Red Bird Redevelopment

RBM/UTSW Clinic

August UDPRP Review

August 28, 2020

Infusion Garden

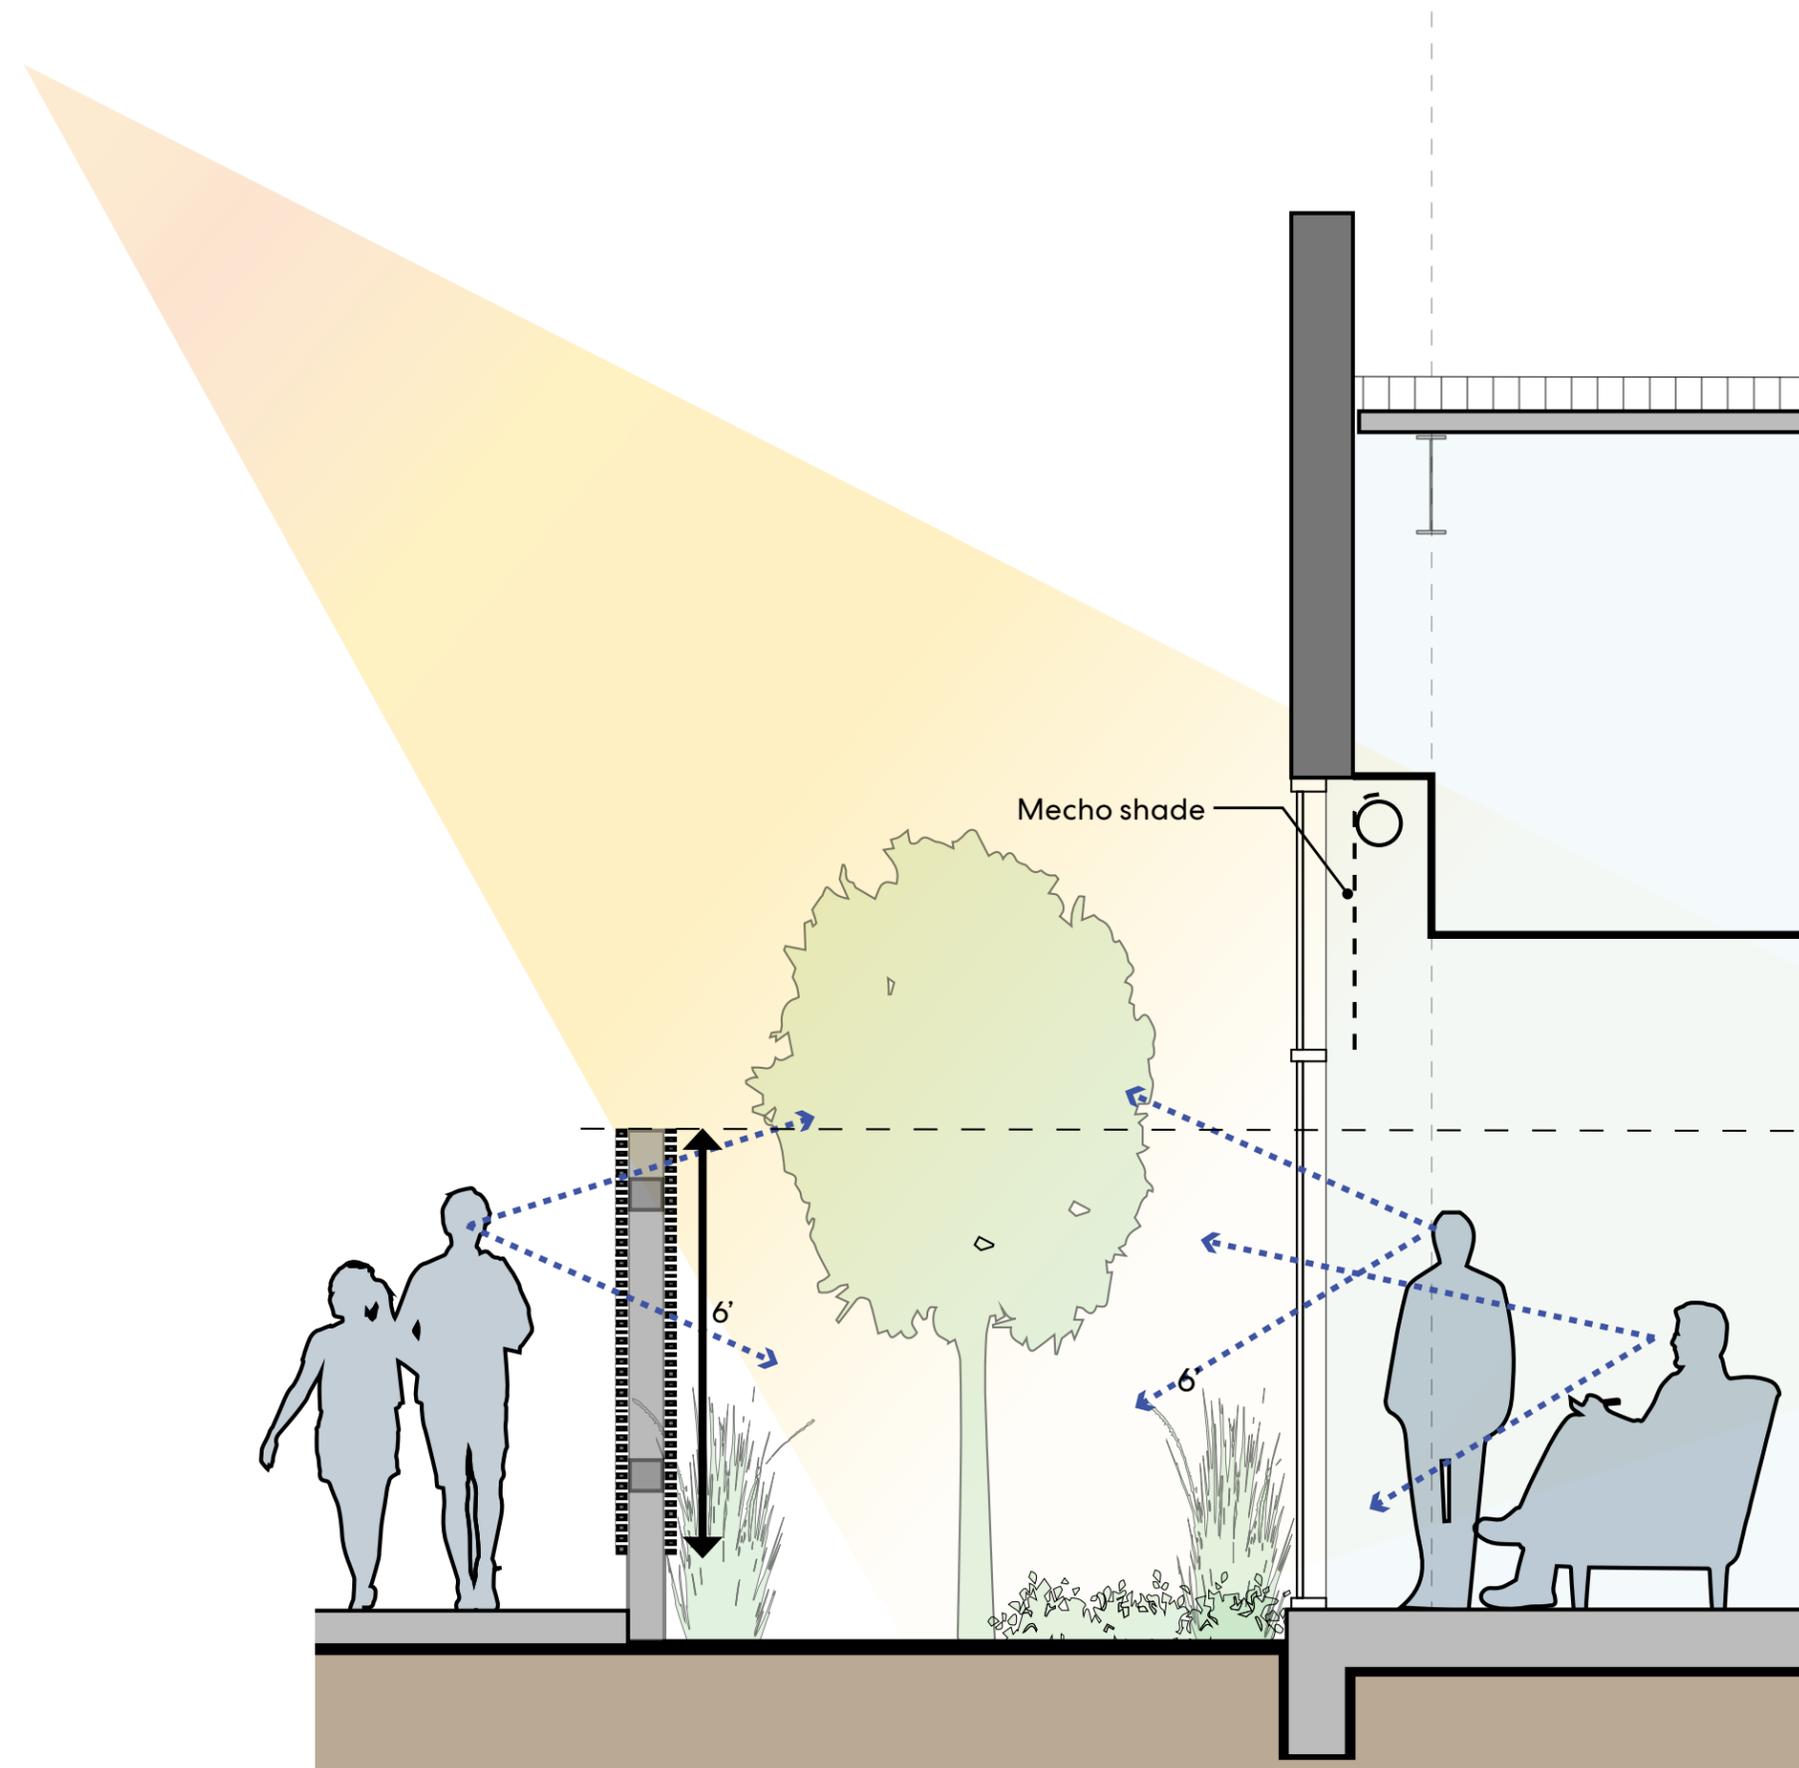
- [3] **Explore opportunities to enhance the treatment of the northern edge of the development to create a more active and interesting pedestrian experience.**

The design of the public realm adjacent to the infusion garden, the design of the fencing along the garden, and the northern facade design should all contribute to an experience that creates interest and pulls pedestrians around the building to the main entrance. This side of the building and its public realm should be designed forecasting potential future development north of the development across the parking drive.

- The purpose of the solid wall is to provide patient privacy within the Infusion department.
- With the garden wall at 6' high, this height to length ratio is appropriate given the scale and use of the Infusion rooms.
- The design team is working with the landscape architect to select appropriate plant materials for the proportion and density of the garden space.
- The height of the wall and proportion of the space are designed to provide appropriate privacy screening, while admitting a maximum amount of natural light to the exam rooms.

Canopy

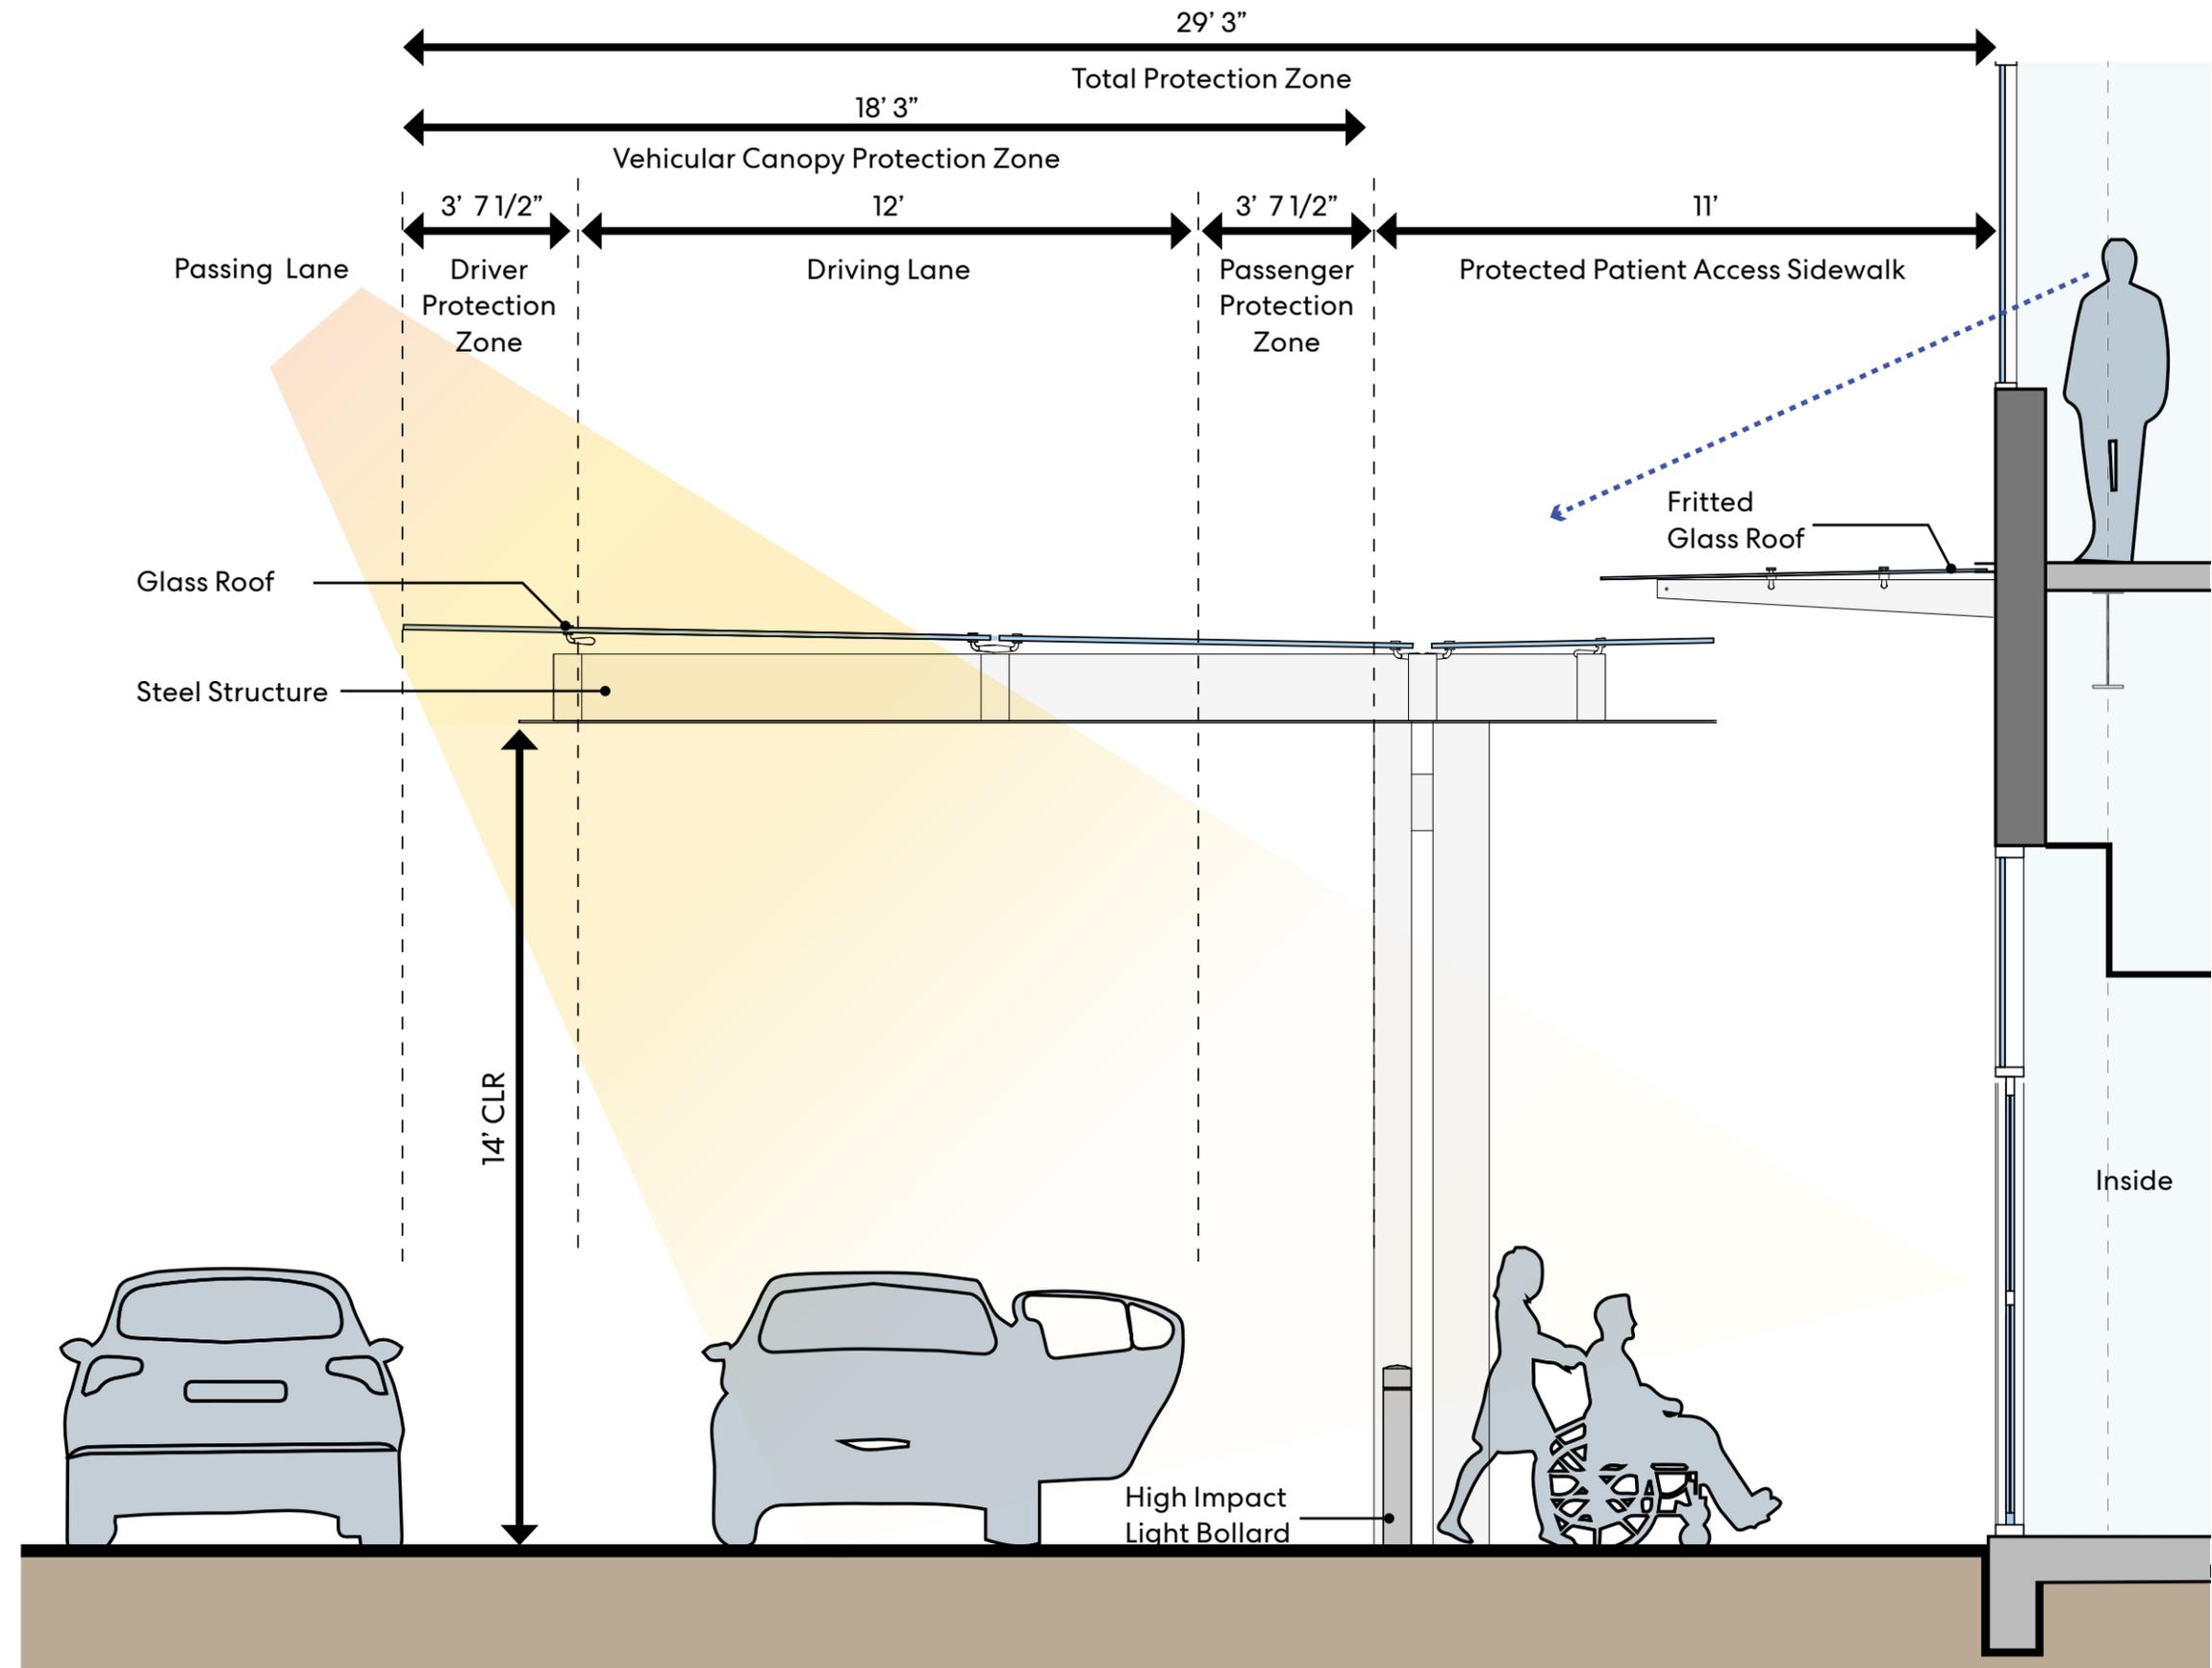
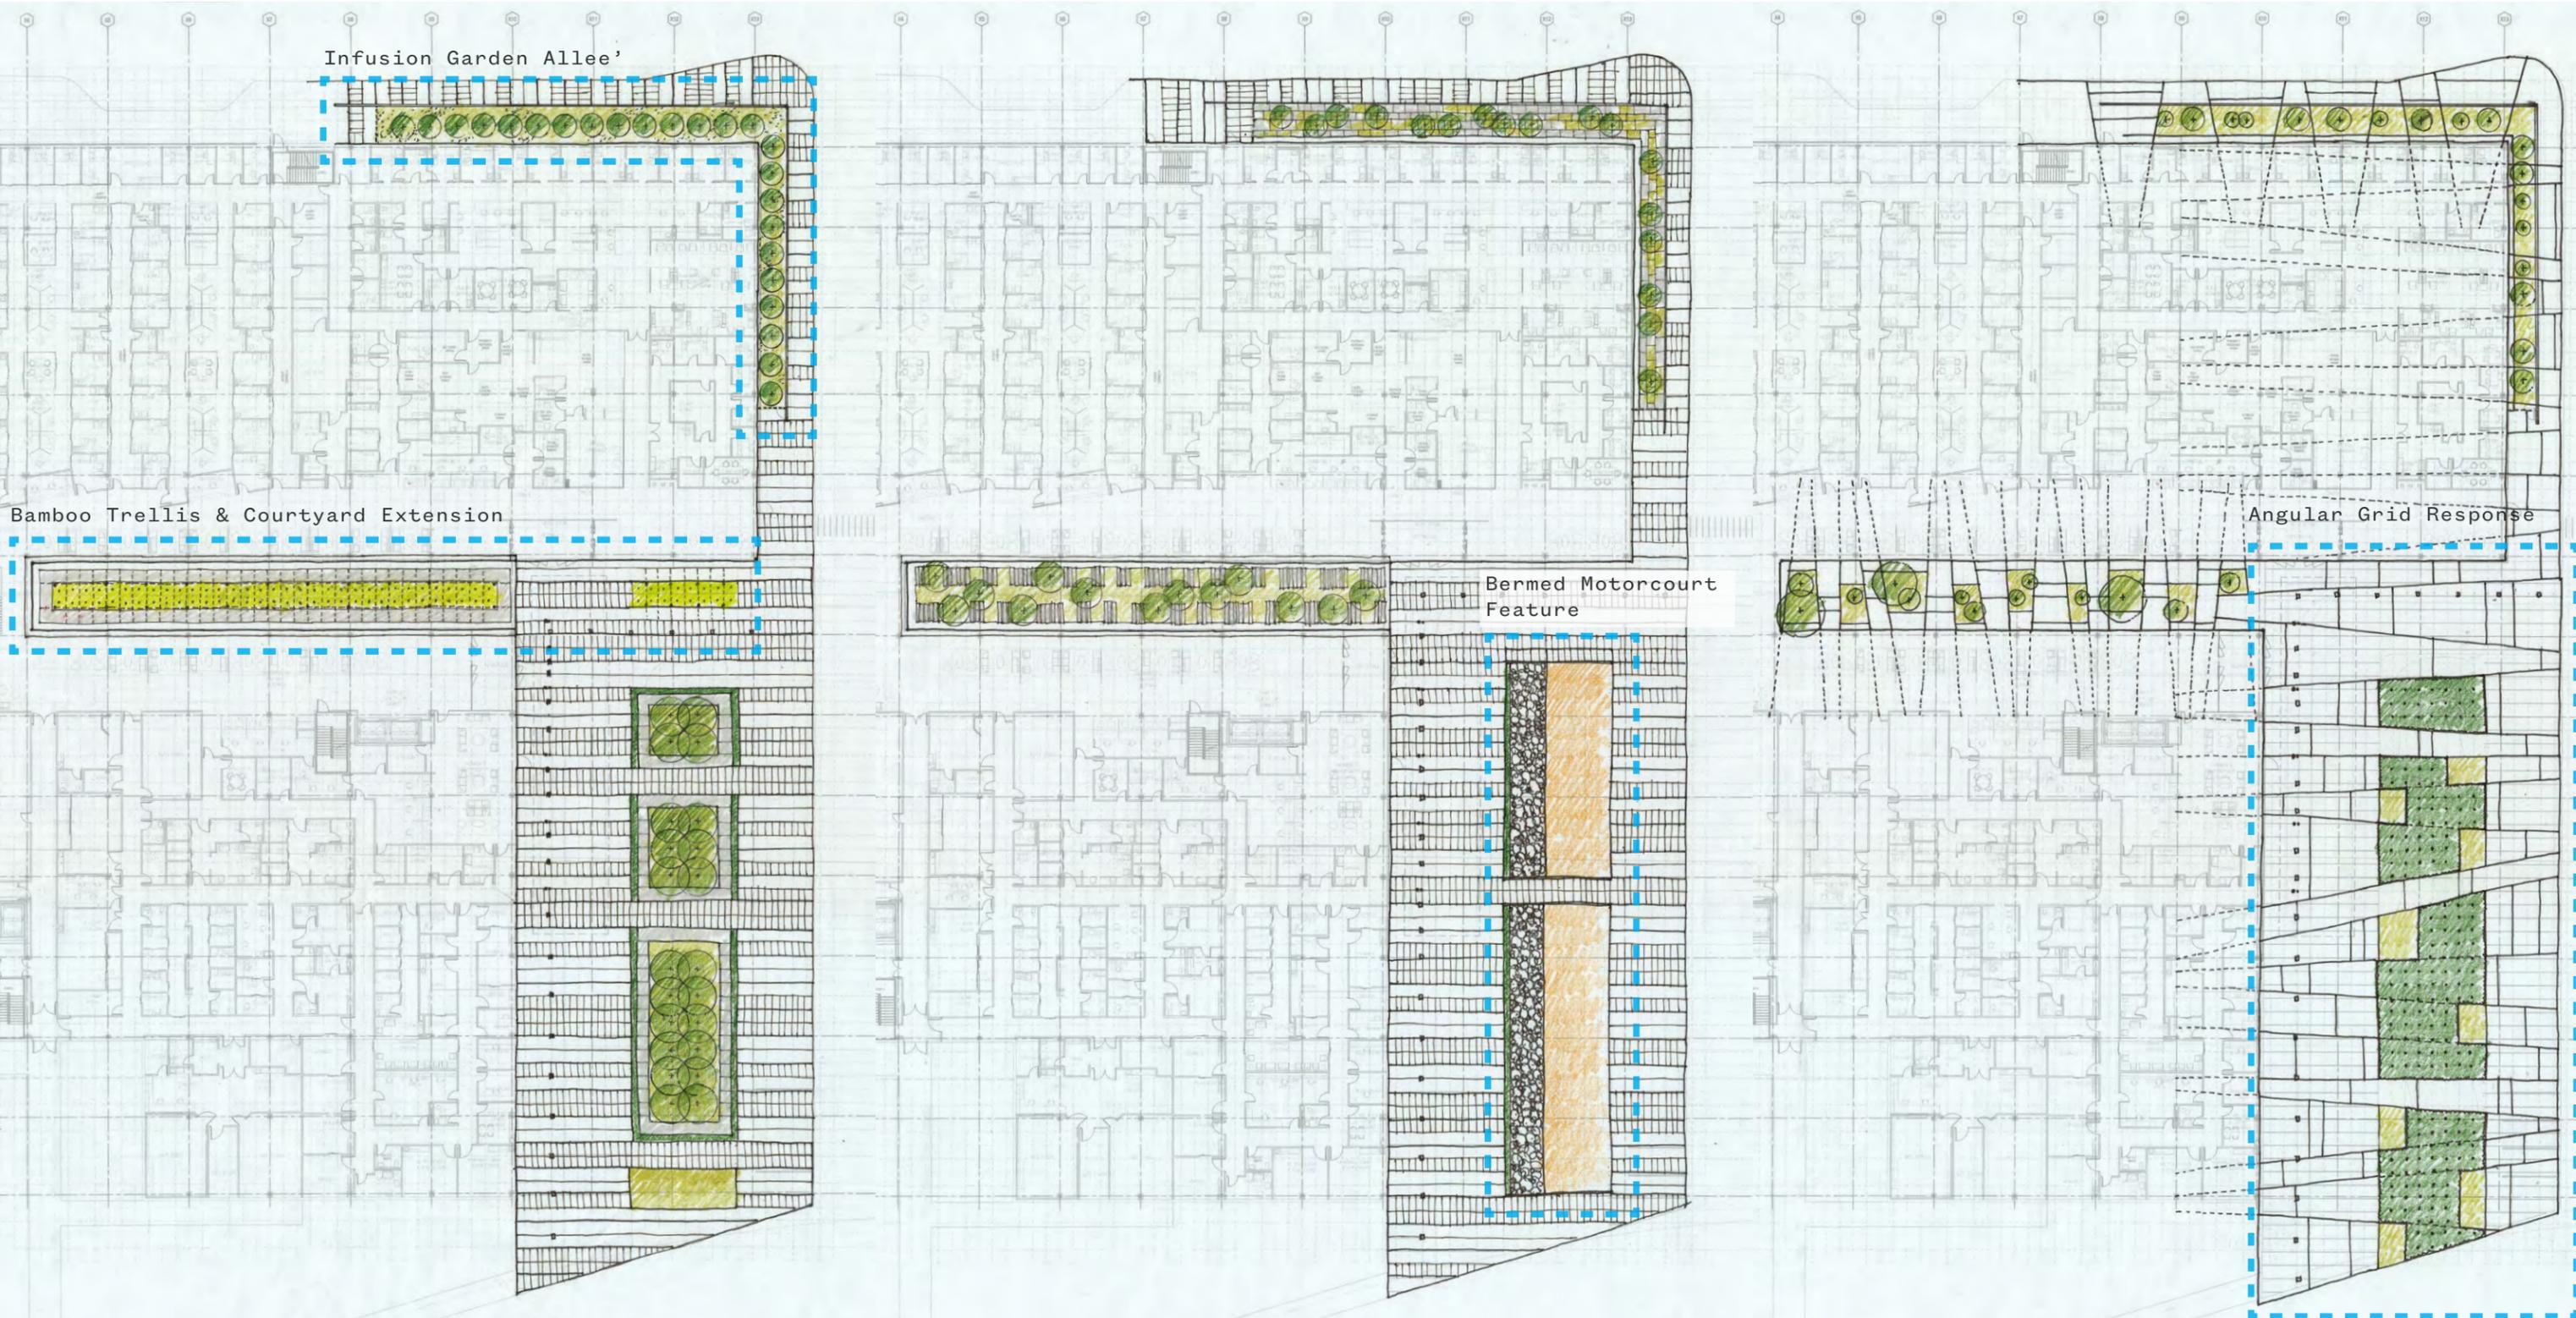
- [1] **Consider the design of the proposed motor court and adjacent open space to create a pedestrian-friendly experience that also allows for a functional and useable open space.**

Aside from providing a clearly demarcated public realm separated from the motor court, explore opportunities to use the open space to create opportunities for shade and respite.

- The design currently has full coverage of the pedestrian walkway, which is about 11' from the edge of the building to the bollards, then 18' 3" of vehicular canopy coverage, please see attached diagram.

- Better visibility for patients entering/exiting from cars
- A friendlier entry experience
- Consistent with overall aesthetic of building
- Clean minimalist appearance
- Glass canopy roof allows much more natural light to enter interior building and the lobby spaces
- Energy efficient (covered would require down lighting)
- Solid structure would be heavier (more weight) construction.
- Dirt will also be more visible on a solid canopy from second story spaces
